INITIAL FIRE SAFETY INSPECTION REPORT

Union Sportswear Ltd. (Extension)

RSC ID: 24726

Inspected By: Md. Sadid Rahman, Md. Najmul Huda and Md. Tanvir Rahman

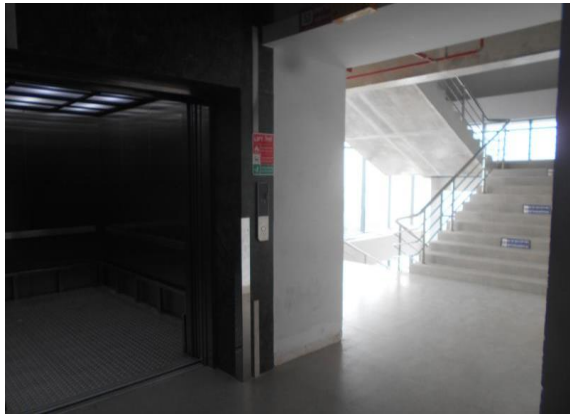
SI No.	Category	Findings	Required Action	Remediation Time Frame
F-1	Fire Rated Construction	<p>The exit stairs are not separated from work areas, other spaces on each floor by fire-rated construction.</p> <p>Location: B#1 New Production Building, B# 4 Ware House Shed</p>	<p>Provide minimum 2-hr fire rated construction for buildings 4 storied or more and 1-hr for up to 3 storied. Seal all unprotected openings to separate the exit stairs from work areas and other spaces on all floor levels by 90 minutes for 2 hr. construction and 60 minutes for 1-hr construction. Ensure that the fire rated doors are self-closing and positive latching and that they are provided with fire exit (panic) hardware where serving production floors. If fire rated doors are required to be held open for functional reasons, provide automatic closing devices tied to the fire alarm system.</p>	Within 3 months

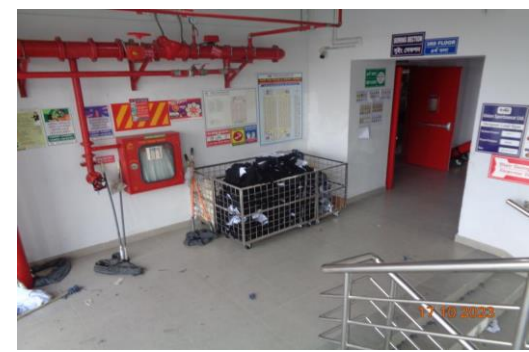
F-19	Fire Protection System (Standpipe & Sprinkler)	The factory has installed a fire Standpipe & Sprinkler system which is required to be reviewed and verified.	<p>Submit as-built drawings, testing records, equipment certification and other relevant documentation to the RSC for review and approval. Modification (if required) shall have to be done as per the reviewed design and NFPA- 20.</p> <p>Upon approval & modification (if required) the factory shall inform RSC to conduct final testing and commissioning verification of the system for final acceptance.</p>	Design within 1 months, installation/modification on within 3 months
------	--	--	---	--
